## DEPARTMENT OF THE AIR FORCE

Subject: Proposed Transfer of Facility Operating License R-130, McClellan Nuclear Radiation Center (MNRC)

TECHNICAL SPECIFICATIONS  
FOR THE  
U.C. DAVIS MCCLELLAN NUCLEAR RADIATION CENTER (MNRC)

Figure 6.1

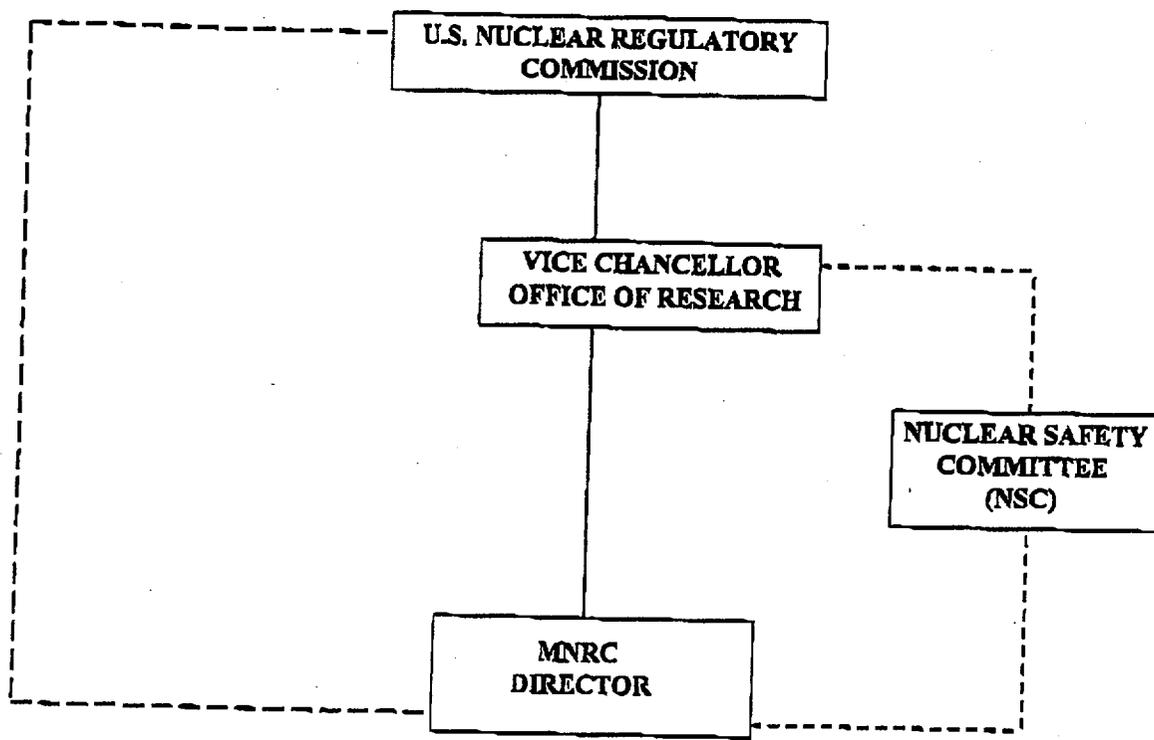
This is to supplement our letter of 13 Apr 99, and subsequent filings with regard to the transfer of Facility Operating License R-130 to the University of California. The attachments hereto explicitly show the proposed changes to the license that would be necessary to reflect the transfer of the license. Our 13 Apr 99 submittal, while requesting that the NRC transfer the license with the University of California, Davis, indicated as the licensee, inadvertently omitted the attachments as part of the initial application for approval of the license transfer which encompassed a conforming amendment request more explicitly detailed here.

The following additional information is supplied in support of the amendment and transfer application. As indicated in the proposed Technical Specifications, I will remain as the on-site Director of the MNRC but as an employee of the University of California. All other current employees, including supervisors, will remain in their present positions. However, they will become employees of the contractor Science Applications International Corporation (SAIC), which will operate the facility under the ultimate control and director of the University of California. My responsibilities as facility Director will remain unchanged.
